HAMM FAMILY DIVISION SUBDIVISION

APPLICATION NUMBER 2 DATE August 21, 2014

APPLICANT Hamm Family Division Subdivision

DETAIL SITE PLAN

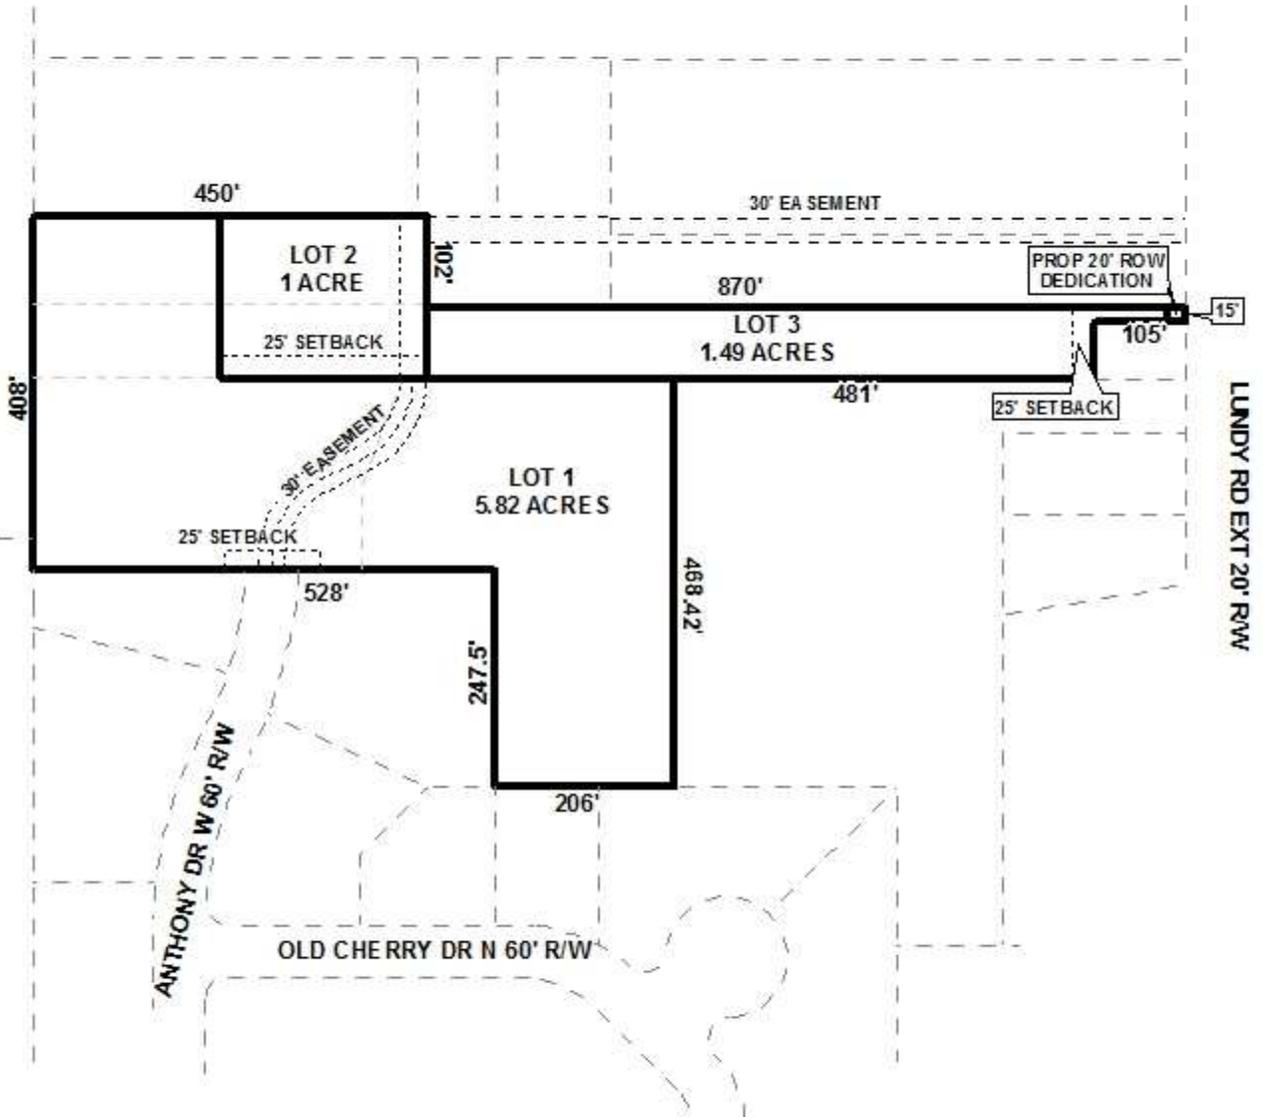
As shown on the preliminary plat, the 25' building setback line for Lot 1 should be blocked at the North terminus of Anthony Drive West. The plat should be revised to stop the 25' building setback line along the South side of Lot 2 where it would meet a 25' setback from the 30' easement for ingress and egress. The plat should also be revised to illustrate such setback line from the easement.

It should be noted that Planning GIS identified an error in the legal description along the East side of proposed Lot 2 indicating a length of 102.00' as opposed to the 184.53' as indicated graphically. This should be corrected on the Final Plat, if approved.

Lot 3 would have frontage on Lundy Road Extension which is a substandard 20' public right-of-way without curbs and gutters. Therefore, as indicated on the plat, dedication to provide 30' from the centerline of Lundy Road Extension would be required. As a means of access management, a note should be required on the Final Plat stating that Lot 3 is limited to the existing curb cut to Lundy Road Extension, with the size, location and design to be approved by County Engineering and conform to AASHTO standards. And as on the preliminary plat the 25' minimum building setback line for Lot 3 should be illustrated on the Final Plat as measured where the lot is at least 60' wide.

Although Lot 2 is essentially land-locked, access to that area was granted via an easement for ingress and egress from Lundy Road Extension recorded in 2001 and an additional ingress/egress easement from Anthony Drive West is proposed. Other family subdivisions have been approved by the Commission in instances where ingress/egress easements were recorded prior to the subject sites coming within the Planning Jurisdiction. However, a note should be required on the Final Plat stating that no further resubdivision of Lots 1 and 2 is allowed until additional public street frontage is provided.

- 5) revision of the plat to stop the 25' building setback line along the South side of Lot 2 where it would meet a 25' setback from the 30' easement for ingress and egress;*

- 6) revision of the plat to illustrate a 25' setback line from the ingress and egress easement;*
- 7) retention of the 25' building setback line for Lot 3 as measured where the lot is at least 60' wide;*
